# Access Compliance Report

## Public Rights-of-Way

Intersection ID: 51609	Main Street: MASTERTON_RD	Cross Street: MOSSBURN_RD	Location: NE
ADA ID: 42ECFAB85BD5	Ramp Type: Perp	Initial Pass/Fail: Fail	Overall Compliance: No
Severity Score: 26.25			
Codes/Mitigation Info/Possible Solution		Field Measurements/Component Compliance

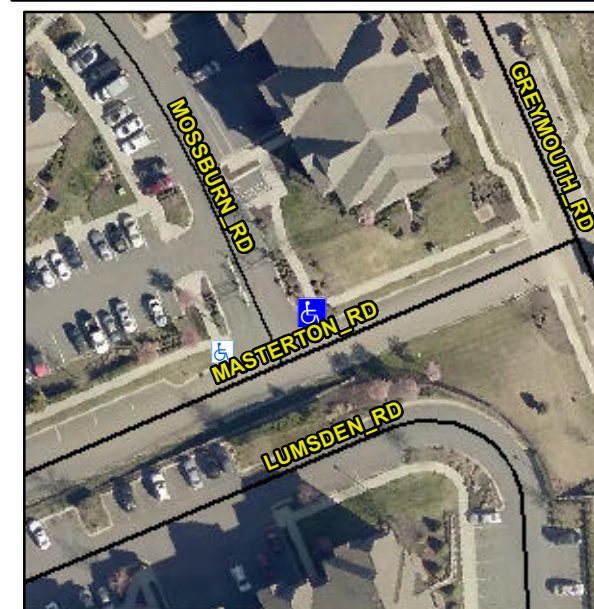
**R304.2.2, R304.5.3**

Compliance	Description	Data	Compliance	Description	Data
N/A	Ramp Length (in)	77.0	No	Ramp Slope (%)	16.1
Yes	Ramp Width (in)	59.5	No	Ramp XSlope (%)	4.1
N/A	Flare Type LT	N/A	N/A	Flare Type RT	N/A
N/A	Flare Slope LT (%)	N/A	N/A	Flare Slope RT (%)	N/A
N/A	Flare Traversable LT?	N/A	N/A	Flare Traversable RT?	N/A
N/A	Landing Length (in)	N/A	N/A	DWS Provided?	N/A
N/A	Landing Width (in)	N/A	N/A	DWS Contrast?	N/A
N/A	Landing Slope (%)	N/A	N/A	DWS Length (in)	N/A
N/A	Landing X Slope (%)	N/A	N/A	DWS Full Width?	N/A
N/A	Landing Curb? (Y/N)	N/A	N/A	DWS Offset (in)	N/A
N/A	Shared Landing?	N/A			
N/A	Gutter Ponding?	N/A	N/A	Gutter Slope (%)	N/A
N/A	Gutter Lip Ht (in)	N/A	N/A	Gutter X Slope (%)	N/A
N/A	Painted X Walk1?	No	N/A	Painted X Walk2?	N/A
	X Walk 1 Direction	To W		X Walk 2 Direction	N/A
N/A	X Walk 1 Width (in)	N/A	N/A	X Walk 2 Width (in)	N/A
	X Walk 1 Slope (%)	6.6		X Walk 2 Slope (%)	N/A
	X Walk 1 X Slope (%)	5.5		X Walk 2 X Slope (%)	N/A

**Remove & Replace Entire Ramp.**
